# Diagrams pertaining to HP comments on sam2r23

Author: Randy Haagens  
 T10 document: T10/02-153r0  
 Date: 21 Apr 2002  
 Author contact: Randy\_Haagens@hp.com

## Need Composite Layer Diagram

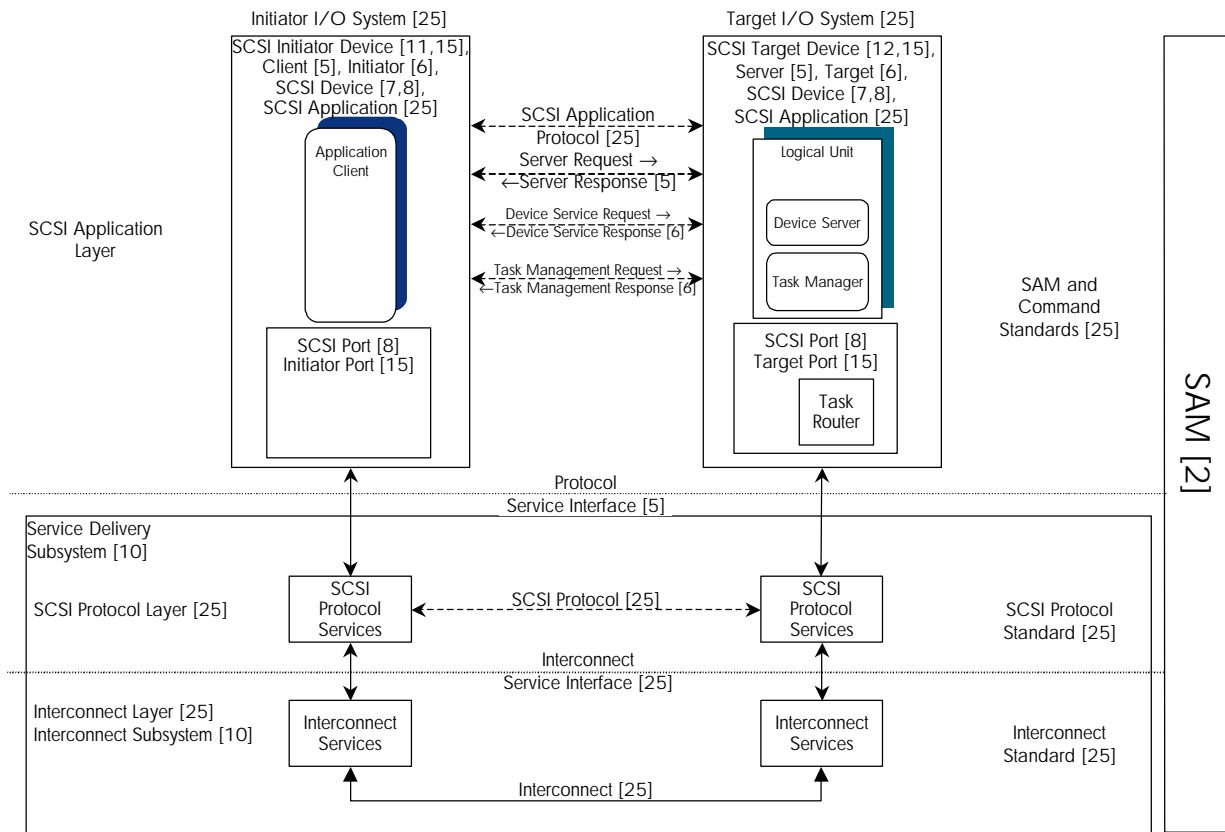
The current draft of SAM (r23) includes many different layering diagrams, with conflicting terminology. The diagram below is a composite diagram, with information from each of the figures that illustrates the conflicting terminology. References to the figures are shown in [square brackets].

# The SCSI model for distributed communications

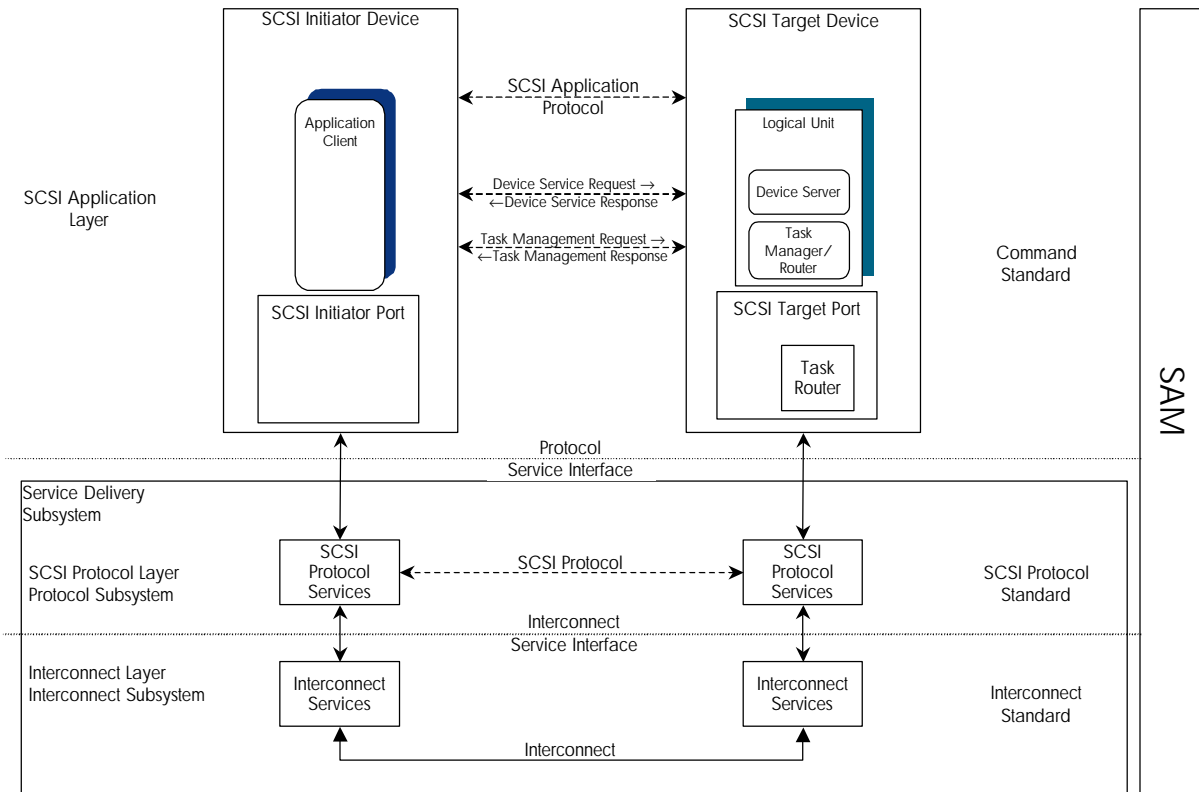
We suggest that alternatively, a single composite layer diagram be used, and that where appropriate, subsets of the diagram be reproduced in the various SAM sections. Below is an example layer diagram that removes all the redundant terms.

Note that in this model, the SCSI Initiator Port and SCSI Target Port are shown as entities entirely above the Protocol Service Interface. We believe that this model is most consistent with the definitions text and with the several figures.

## Need Composite Object Diagram

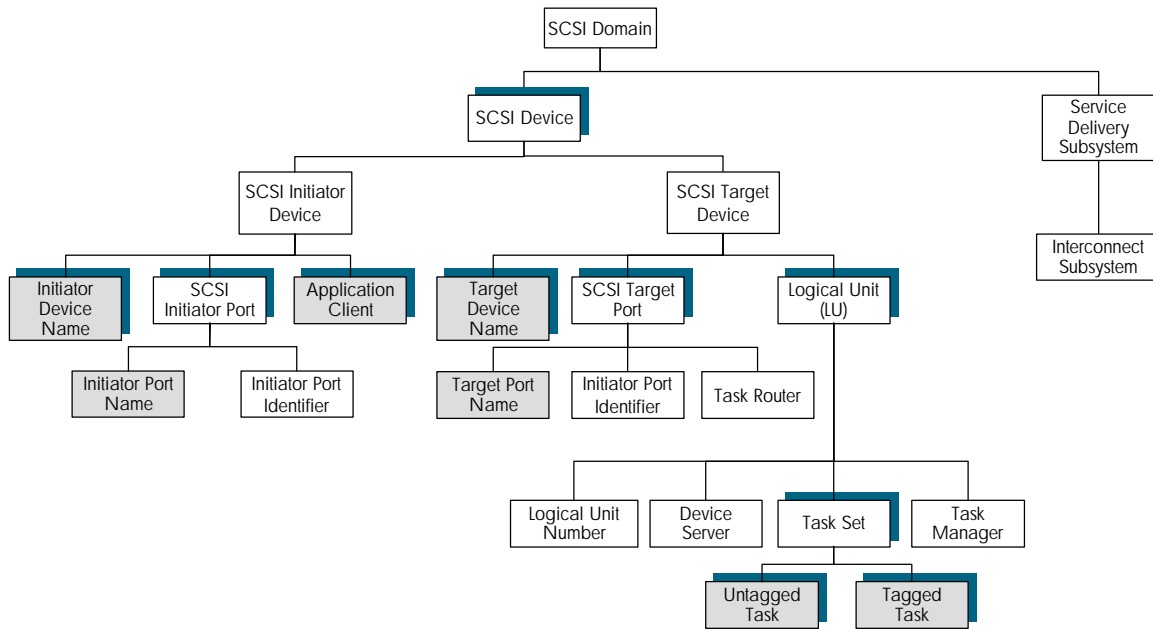
The SCSI object model is not so complex that it needs to many individual, partial depictions. The entire model can be drawn on one page, as indicated below:

# SCSI Model

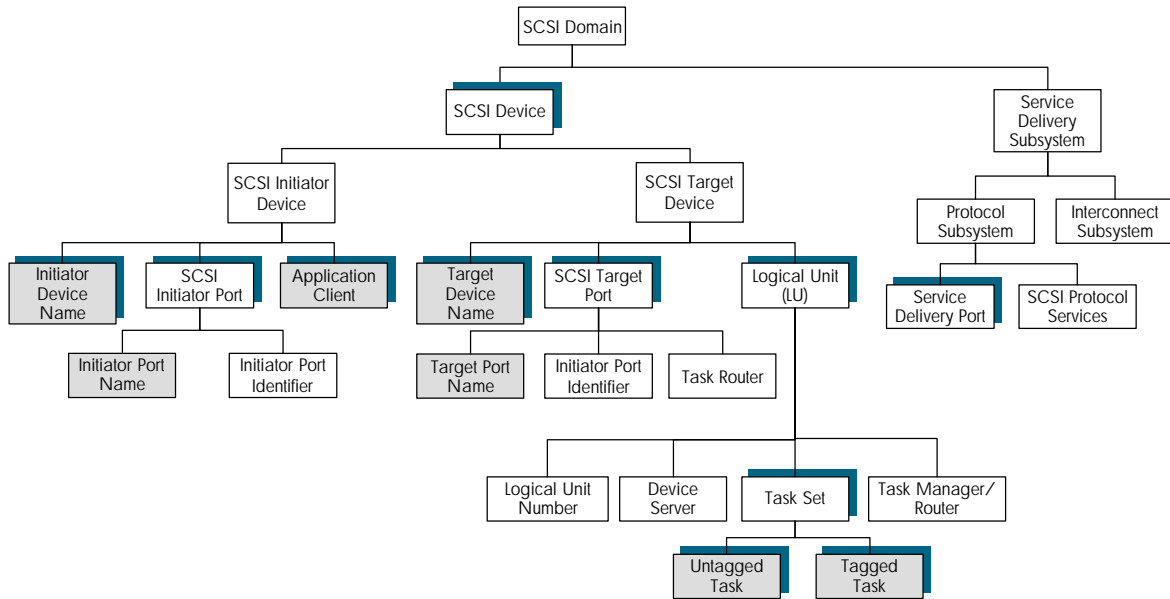
We suggest that a single, composite model diagram be used, and that where appropriate, subsets of the diagram be reproduced in the various SAM sections. Below we have shown a diagram with some changes and additions.

This diagram implies other changes to SAM:

1. No such thing as a Target/Initiator device. In this model, a SCSI device can include a SCSI Initiator Device, a SCSI Target Device, or both. Device names and Port names and identifiers may be the same or different.
2. The Service Delivery Subsystem is shown to contain more than just the Interconnect Subsystem. The Protocol Subsystem also is called out, along with its Service Delivery Port and Protocol Services. This re-introduces the notion of a Service Delivery Port, as an object within the Protocol Subsystem. The Service Delivery Port is in correspondence with the SCSI Target (or Initiator) Port, but it is not the same thing.
3. The Task Manager is renamed Task Manager/Router, to allow for task routing to dependent LUs. Arguably, a separate Task Router and Dependent LU could be shown in the diagram.
